Paraiso Springs Resort – Response to Hydrology and Hydraulic Analysis and Erosion Control Measures Review Comments

TO: Thompson Holdings, LLC

FROM: Meabon Burns P.E./CH2M HILL
Erika Powell P.E./CH2M HILL

DATE: October 28, 2008

ATTACHMENT 4A
 Project Watershed
 Paraiso Springs Resort Subbasin Delineation

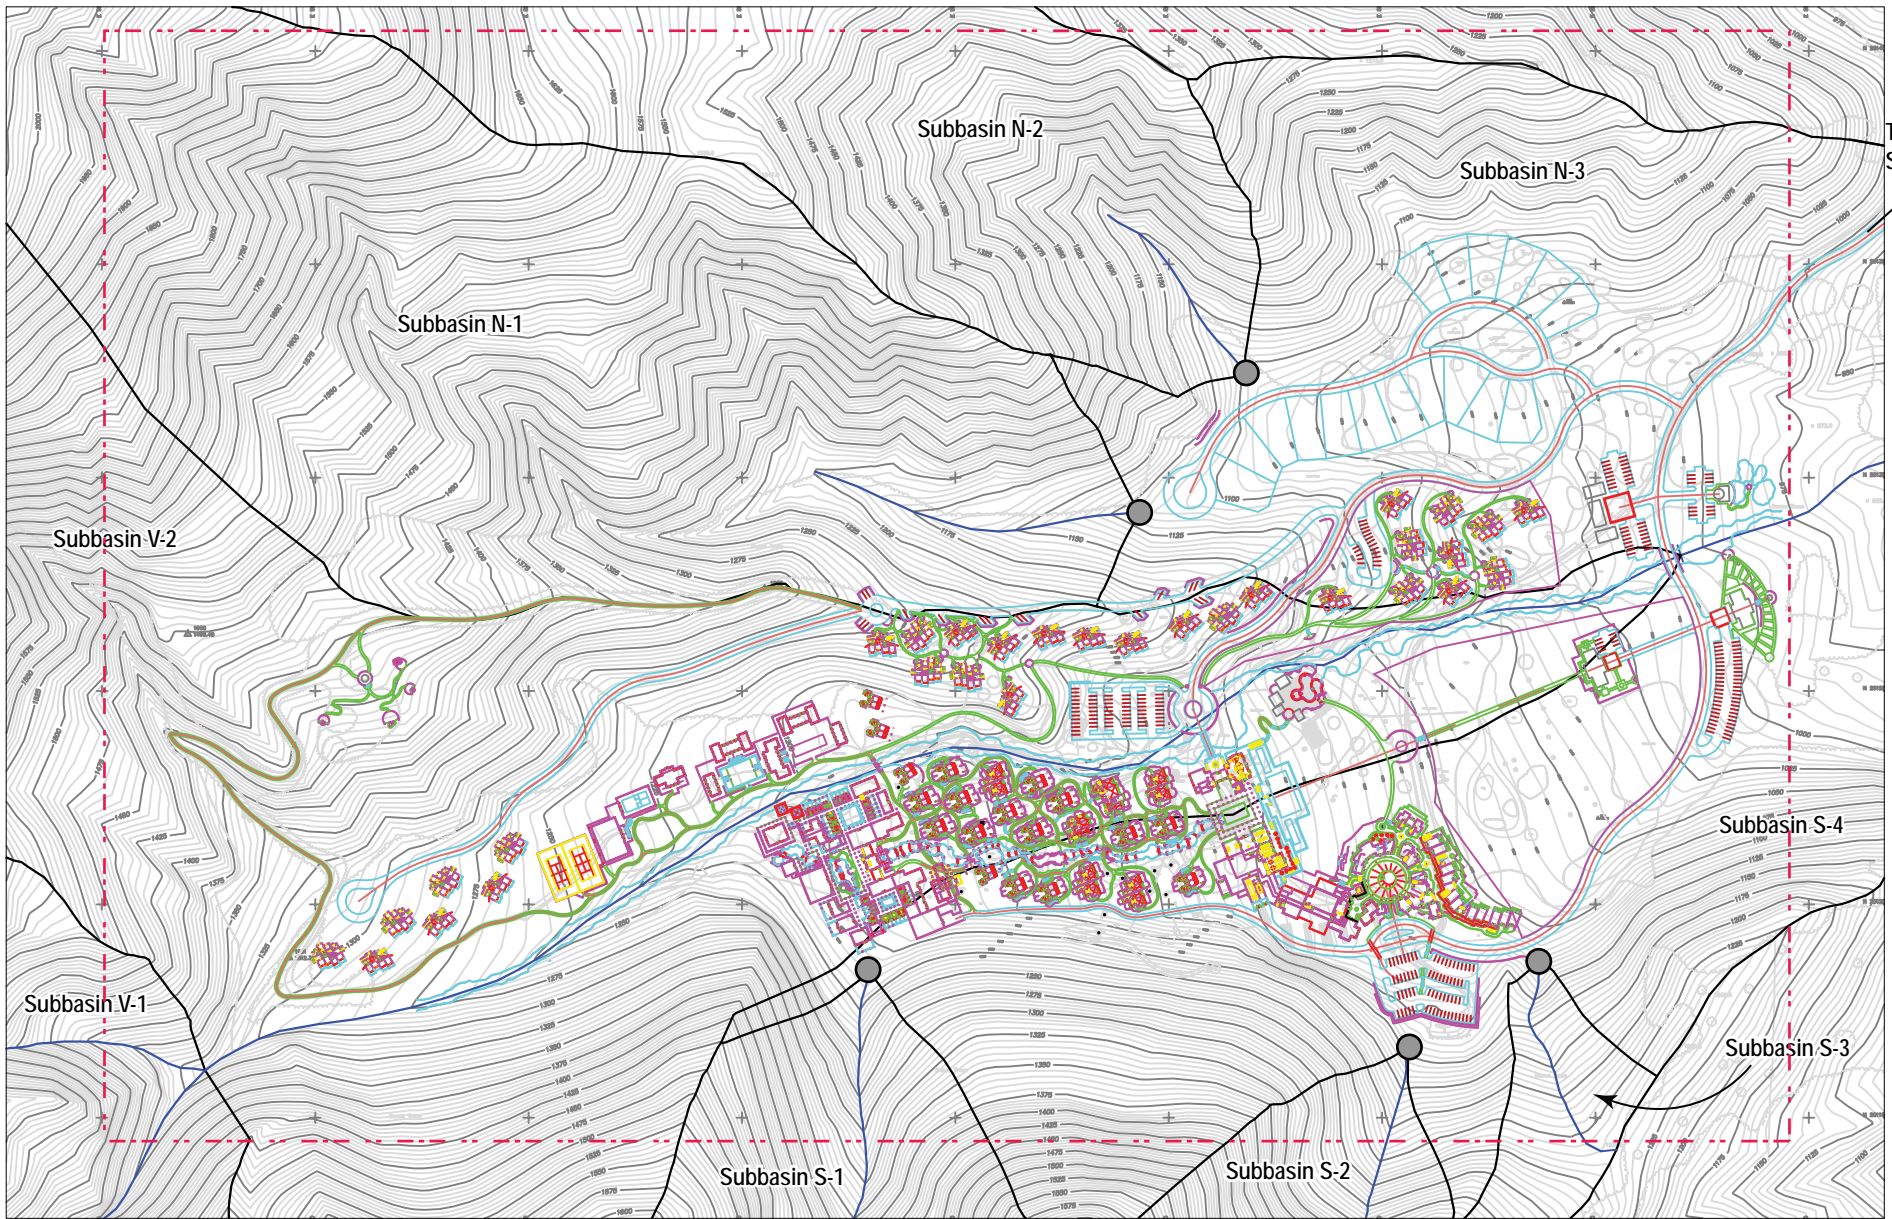
2. The statement, "Topographic contour patterns show that there are four points within the basin that collect and transfer flows from the higher areas of the basin to the existing stream," is not supported by the exhibit. Additional clarification should be provided.

2. Maps showing the subbasin delineation for the Project watershed and Project site are included in Attachment 4. The Project watershed was delineated into nine subbasins. These subbasins were delineated because they either had distinct drainage characteristics or the flows collected at a location where specific project impacts could be identified, such as the potential for landslides or debris flows.
